County of Fairfax, Virginia

STAFF REPORT

APPLICATION RZ/FDP 2013-MV-001

HUNTINGTON AVENUE PROPERTIES

Figure 28 from Comprehensive Plan

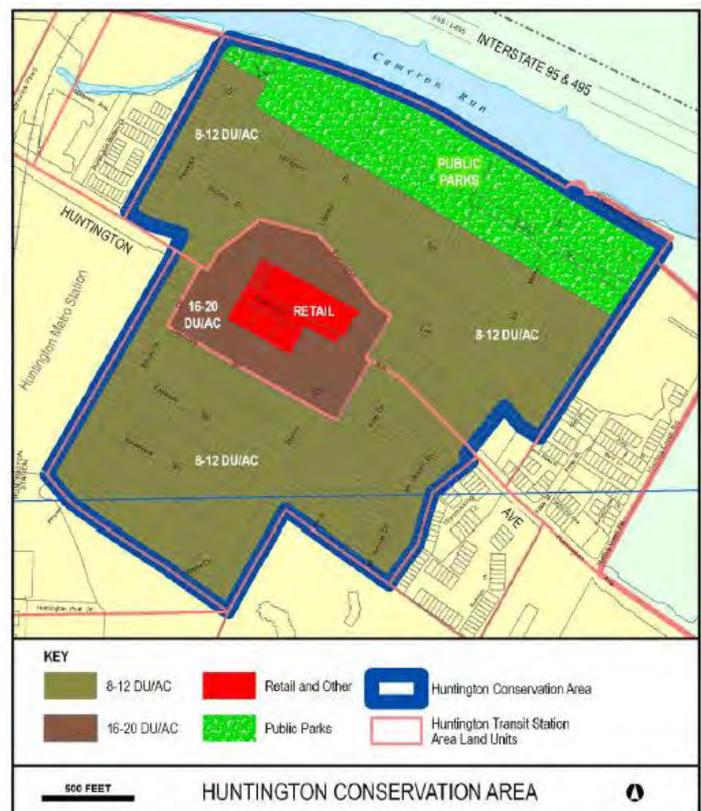
...In the center of the Huntington Conservation Area on either side of Huntington Avenue is Land Unit T, an area developed with duplexes, garden apartments and local retail uses. This 10-acre area is planned for residential use at 16-20 dwelling units per acre with a retail component of up to 20,000 gross square feet to provide local services to the neighborhood (see Figure 28). Substantial consolidation of parcels is required in order to attain this level of development. To maintain the scale and character of the adjacent residential neighborhood, redevelopment of Land Unit T should:

- Respect a building height limit of three stories on the north side of Huntington Avenue; on the south side of Huntington Avenue, buildings should be within a three-story height as established along Glendale Terrace due to the sloping topography;*
- Provide landscaping between the existing residential uses and areas redeveloped with nonresidential uses or parking facilities to buffer the residential areas from adverse impacts;*
- Encourage the retention and rehabilitation of existing garden apartments on the site; and*
- Coordinate building design, massing and open spaces on both sides of Huntington Avenue.*

The Comprehensive Plan's site specific recommendations limit building heights to 120 feet adjacent to Huntington Avenue closest to the metro station and 40 feet along Glendale Terrace. As demonstrated in the elevation below, the building is seven stories (80 feet) in height along Huntington Avenue and the majority of the building's façade along Biscayne Drive is six to seven stories in height.

The building then transitions to three stories in height along Glendale Terrace. While the proposed building conforms to the maximum heights specified in the Comprehensive Plan, the Plan does not provide guidance on tapering of building height along Biscayne Drive. Glendale Terrace and Biscayne Drive are similarly situated adjacent to duplexes along residential streets; therefore, staff believes that the impacts of redevelopment should be given similar consideration. Staff appreciates the revisions that the applicant has made to attempt to address staff's concern regarding compatibility along Biscayne Drive with the adjacent residential neighborhood, including a greater setback at level three of the building with private patios, a terraced plaza at ground level, and some slight terracing of the upper levels from the primary building façade. However, staff feels that the townhouse-style design and scale demonstrated along Glendale Terrace provides the transition needed to protect the character of the surrounding neighborhood.

Alternative Huntington Avenue Elevation without Retail

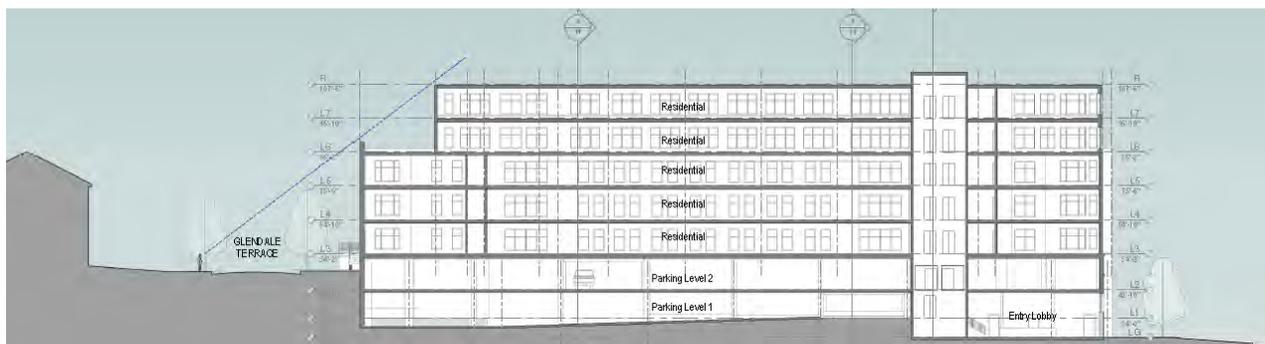
An option for residential use without retail, shown in the image to the right, is also depicted on the CPD/FDP. The portion of the building along Glendale Terrace features first-floor units with direct access to the street, as shown in the image below. The elevations provided on the CDP/FDP display a mixture of building materials, including masonry, composite metal/fiber cement panels, and metal coping. The masonry is primarily shown at the first five levels of the building, while the top levels contain composite metal / fiber cement panel and metal coping.

The applicant's proposal includes an option for the retail component on Huntington Avenue to be substituted with residential units or residential amenities if the applicant is unable to secure retailers within 12 months of the submission of the building permit for the building. Staff questions the likelihood of retail actually being provided within the development given this short recruiting timeframe, the absence of any parking spaces to serve the retail, and the sub-standard size of the retail spaces. Staff is also unclear on how this option will work from a building plan and construction standpoint if the applicant intends to build the maximum number of residential units. Staff does not support the proposed alternative of residential units from both an urban design and land use perspective. In terms of design, the residence entrances are located on Huntington Avenue without providing a zone of separation or privacy between the public and private realm. Inclusion of a front porch, steps, or a setback of the doorways from the sidewalk could help achieve a better sense of safety and privacy. This is particularly vital since Huntington Avenue functions as a primary pedestrian connection to the Huntington Metrorail station. The transition plaza and dog park may also need to be removed or redesigned, as they pose a similar concern if windows or additional entrances to the residential units are located along this side of the building.

The Comprehensive Plan calls for ground level retail to provide neighborhood services and opportunities for residents to socialize. Outdoor seating in front of a coffee shop or café would greatly enhance the character of the area and help achieve the goal of encouraging pedestrian activity throughout the day and achieving an appropriate sense of place and a pleasant pedestrian environment. Staff believes that this could not be achieved if there are residential units along the Huntington frontage instead of retail and has concerns about the functionality of the proposed Huntington Avenue streetscape in the absence of the retail uses. To achieve the same underlying goals if retail is not feasible, staff suggests the applicant consider programming the space for a community center rather than residential use.

Proposed “Public Plaza” (shown at the top and left above) and “Neighborhood Plaza” (shown at the bottom right)

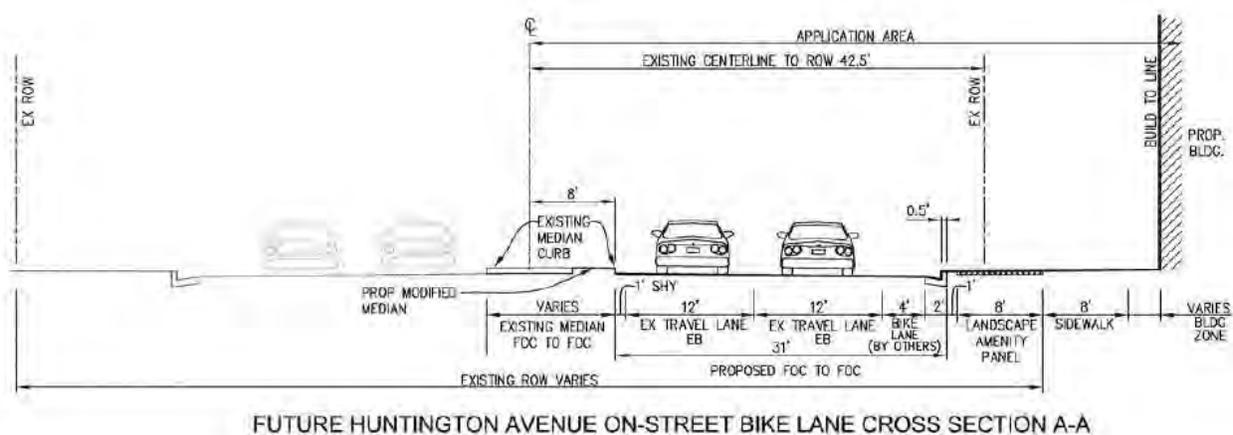
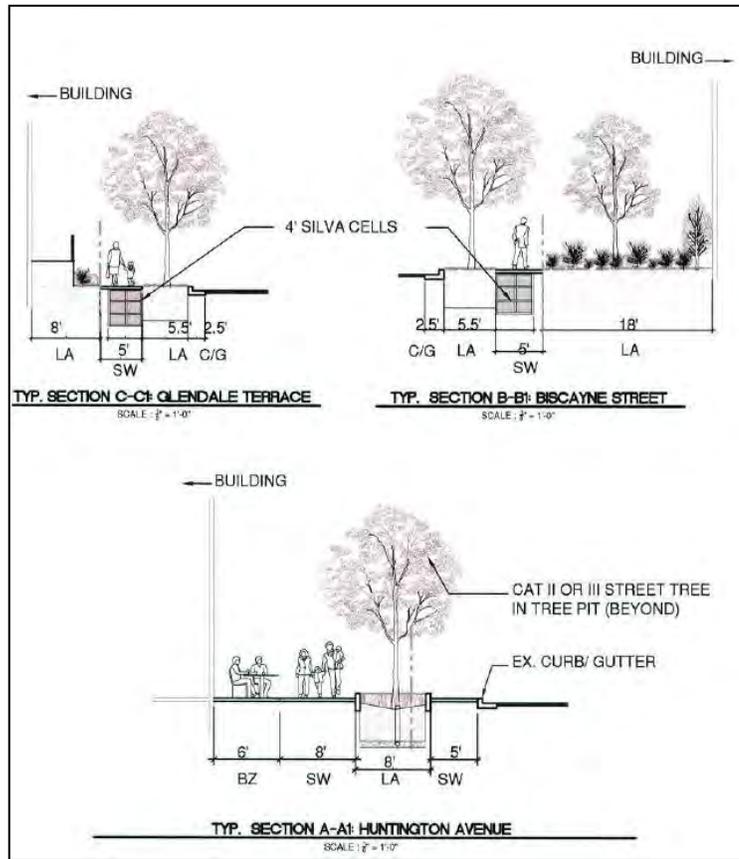
Sheet 21 of the CDP/FDP provides a site open space allocation map and states that a total of 15,019 square feet open space is provided throughout several private and public areas on the site. Approximately 3,549 square feet of this calculated open space is the streetscape along Huntington Avenue. The applicant is proposing one private 4,820 square foot courtyard on the third floor of the building, 730 square feet of private unit patios along Biscayne Drive, 1,072 square feet of private residential frontage along

Glendale Terrace, and four pockets of publicly accessible open space. The publicly accessible open space includes a 1,037 square foot “Public Plaza” along Biscayne Drive (also referred to as “Terraced Plaza”), an 868 square foot “Civic Plaza” near the corner of Biscayne Drive and Huntington Avenue, an 873 square foot “Neighborhood Plaza” near the corner of Biscayne Drive and Glendale Terrace, and a 2,070 square foot “Transitional Plaza” and dog park within an easement along the eastern side of the building. The image below illustrates the proposed “Public Plaza” and “Neighborhood Plaza.”

- While the added park space is a positive addition to the proposed development, staff requests the applicant provide further clarification on the intended use and function of the park space as the majority of the space is considered streetscape.
- The applicant may wish to consider expanding the space and adding a focal feature to activate the space, as well as additional seating options such as gaming tables.
- The applicant should provide a detailed enlargement of the park space similar to those shown on Landscape Sheet #20.

- Applicant should clarify if the overhead structure will be included in the "Terraced Plaza".
- Applicant should provide clarification on the intended use and function of the "Neighborhood Corner" park space on the corner of Biscayne Street and Glendale Terrace. Further, applicant should expand the size of the space, add a focal feature to activate the space, and provide a detailed enlargement similar to those found on Landscape Sheet #20.
